**Grondin Aggregates – Brandy Brook Quarry
Site Plan Amendment**

**Town of Gorham
Planning Board Meeting
December 7, 2020**

ITEM 4 – Site Plan Amendment: Grondin Aggregates, LLC – Brandy Brook Quarry – a request for site plan review and approval of a winter salt storage shed and stump and brush processing at 57 Ossipee Trail. Zoned Rural (R), Suburban Residential (SR), Urban Residential (UR), Map 42, Lot 5. The applicant is Larry Grondin and he is representing himself.

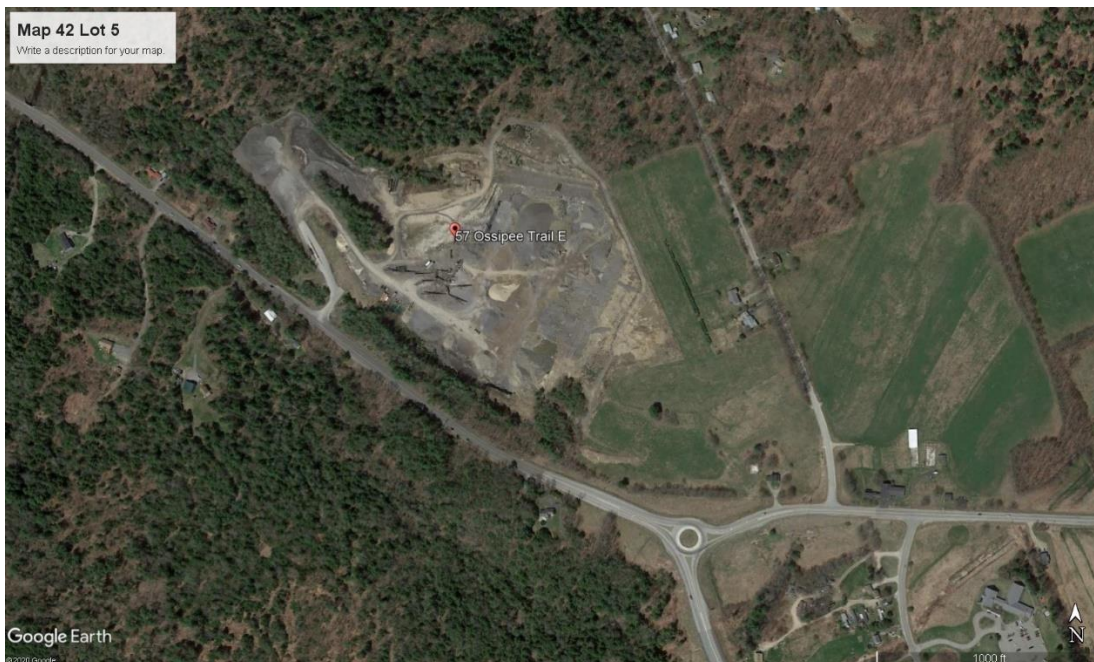
B. The applicant has not provided provision for stabilization and revegetation of regraded areas associated with the storage shed, stormwater drainage and erosion control plan, nor engineering calculations.

C. Staff has included an aerial photographs for the Planning Board's review of the project. The aerial photograph is from Google Earth and was taken in May of 2018.
